SUBJECT: SURRY UNITS 1 AND 2 - ISSUANCE OF AMENDMENTS RE: F DELTA H LIMIT  
AND STATISTICAL DNBR METHODOLOGY (TAC NOS. M81271 AND M82168)

Amendment No. 170  
License No. DPR-32

Amendment No. 169  
License No. DPR-37

SAFETY EVALUATION BY THE OFFICE OF NUCLEAR REACTOR REGULATION  
RELATED TO AMENDMENT NO. 170 TO FACILITY OPERATING LICENSE NO. DPR-32  
AND AMENDMENT NO. 169 TO FACILITY OPERATING LICENSE NO. DPR-37

TS FIGURE 2.1-1

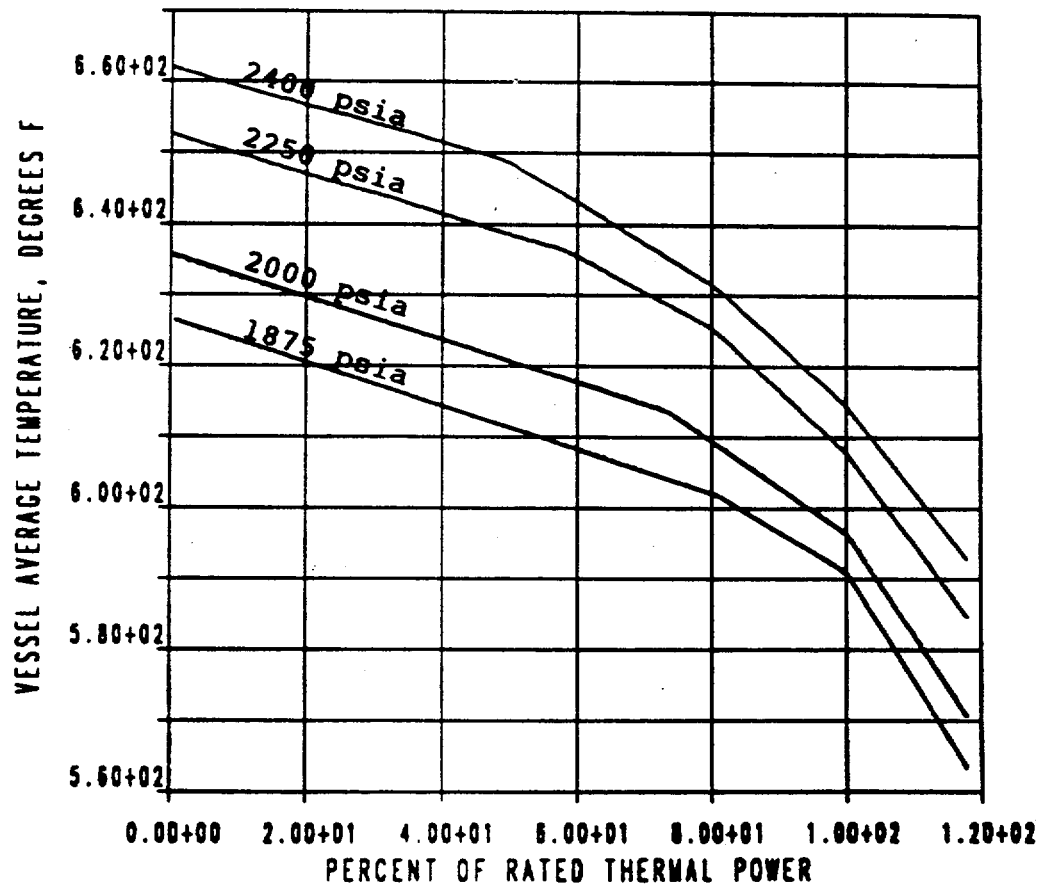
TS Figure 2.1-1 is based on an  $F\Delta H(N)$  of 1.62, a 1.55 cosine axial flux shape, and a deterministic DNB analysis procedure including margin to accommodate rod bowing<sup>(1)</sup>. TS Figure 2.1-1 is also bounding for a statistical treatment of key DNBR analysis parameter uncertainties including an enthalpy rise hot channel factor which follows the following functional form:  $F\Delta H(N) = 1.56 [1 + 0.3(1-P)]$  where P is the fraction of rated power. TS Figures 2.1-2 and 2.1-3 are based on an  $F\Delta H(N)$  of 1.55, a deterministic treatment of key DNB analysis parameter uncertainties, and include a 0.2 rather than 0.3 part power multiplier for the enthalpy rise hot channel factor.

- d. TS Figure 2.1-1 - change to reactor core thermal and hydraulic safety limits to reflect 1.62 F-delta-h.
- e. TS 3.12-3 - change to equation for F(N)-delta-h to reflect F-delta-h surveillance limit; change in line referring to above equation; change to F-delta-h surveillance limit value in discussion of maintenance operation within hot channel factor limits.

TS FIGURE 3.12-8

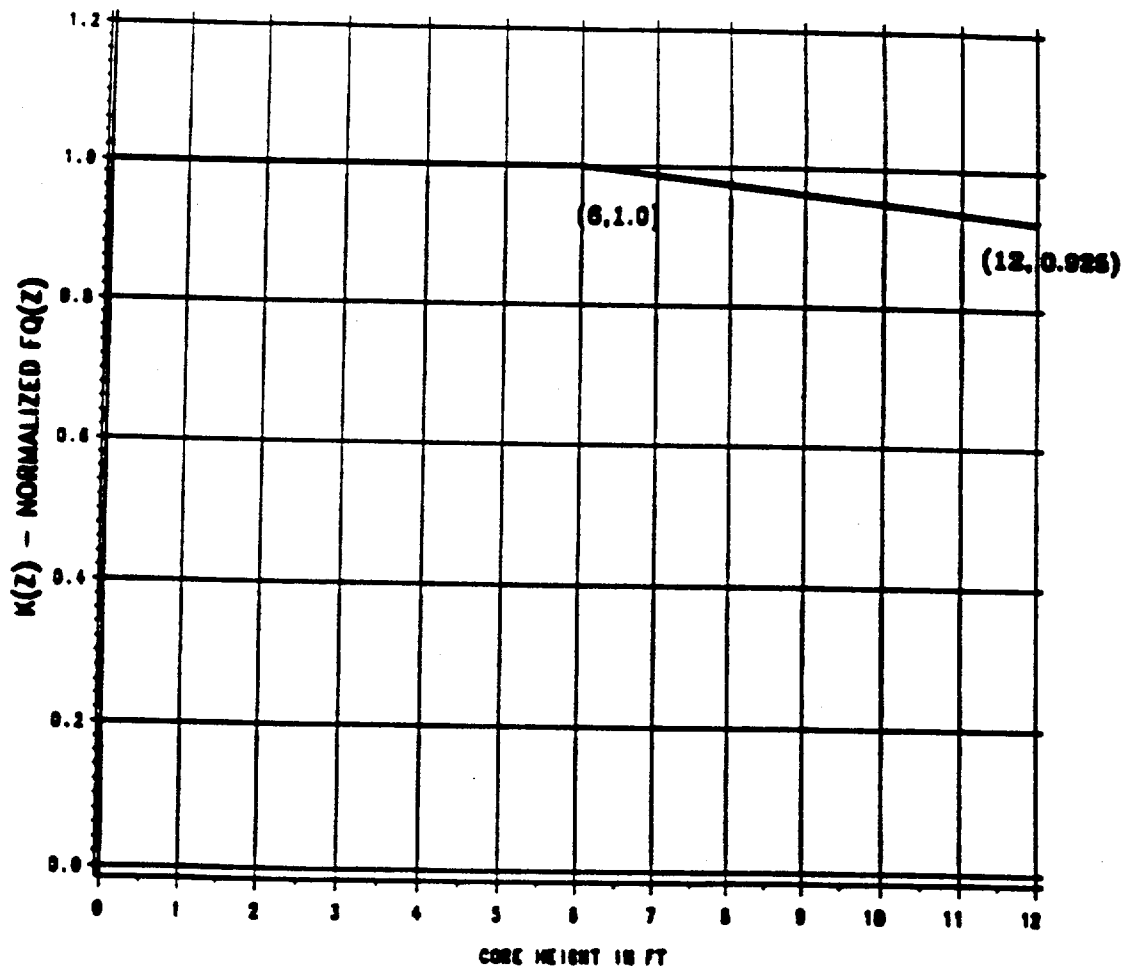
- k. TS 3.12-19 - Bases discussion is added for DNB parameters specified on TS pages 3.12-11 and 3.12-11a.
- l. TS Figure 3.12-8 - change to hot channel factor normalized operating envelope, to reflect changed F-delta-h.
